## Department of Energy

The U.S. Department of Energy requests revision of Nuclear Regulatory Commission Certificate of Compliance No. 5957 for the BMI-1 cask to reflect a change in one of the parameters for irradiated, low-enriched uranium MTR-type fuel assemblies, an authorized content per paragraph 5(b)(1)(xvii). Specifically, we request revision of paragraph 5(b)(2)(xvii) to increase the maximum allowable burnup from 12% to 14%.

**Subject:** Request for Authorization to Ship Irradiated Materials Test Reactor (MTR) Type Fuel Assemblies with up to 14% Burnup in the BMI-1 Cask (OPE-TP-99-005)

# **BMI-1 Cask Amendment for University of Virginia LEU MTR-Type Fuel**

**Figure 1-1.** Loading configuration of LEU MTR-type fuel assemblies in the BMI-1 Cask. This diagram shows the location of the eight fuel assemblies loaded in the peripheral compartments of the BMI-1 basket and four aluminum inserts placed in the four center compartments of the basket.

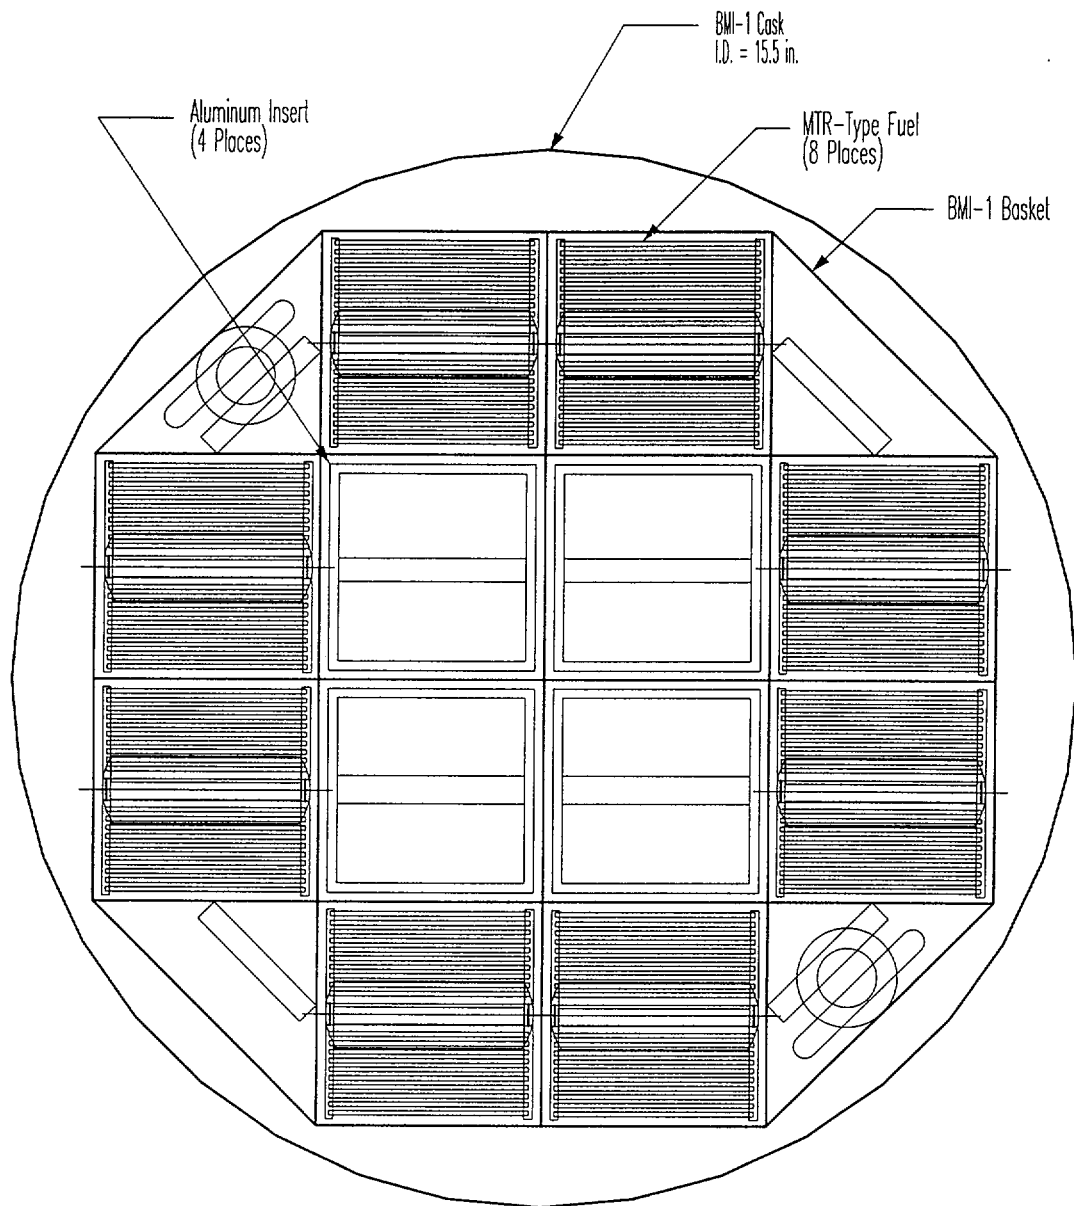
This request is for authorization to transport up to eight University of Virginia LEU fuel assemblies in the BMI-1 packaging. The LEU fuel assemblies have (a) up to 282.7 g U-235 (b) maximum burnup of 14%, (c) maximum decay of 15 watts, and (d) minimum cool down period of 120 days. The fuel assemblies will be transported using the Texas A&M basket configuration. The eight fuel assemblies will be loaded in the peripheral compartments of the 12-compartment basket (see Figure 1-1). The four center compartments will contain aluminum inserts instead of fuel assemblies as shown in Figure 1-1.

Loading of LEU MTR-type fuel assemblies in the Texas A&M basket configuration will be as shown in Figure 1-1. Eight LEU fuel assemblies will be loaded in the peripheral compartments of the basket. The four center compartments will be loaded with square aluminum inserts rather than fuel. These four aluminum inserts will ensure that criticality safety is provided during normal and hypothetical accident conditions of transport. The inserts prevent loading the cask with more than eight fuel assemblies. In the unlikely event of a hypothetical accident of a free drop on the side of the cask, the four aluminum inserts will provide assurance that the eight fuel assemblies will remain in a critically safe geometry in the peripheral compartments of the basket. In addition, the four aluminum inserts will provide structural protection to the center portion of the basket's dividing cruciform which contains the boral neutron poison material.

2. Prior to loading the University of Virginia fuel assemblies in the Texas A&M basket, the four aluminum inserts (Lockheed Martin Dwg. No. 507584, Rev. 1) must be placed, with the lifting bails located at the top of the basket, in the center four compartments of the BMI-1 basket as shown in Figure 1-1.

3. The University of Virginia fuel assemblies must be placed in the eight peripheral compartments of the BMI-1 basket as shown in Figure 1-1. The fuel assemblies must be loaded upright with the fuel assemblies lifting bail at the top of the basket to ensure proper positioning of the fuel relative to the basket poison material.
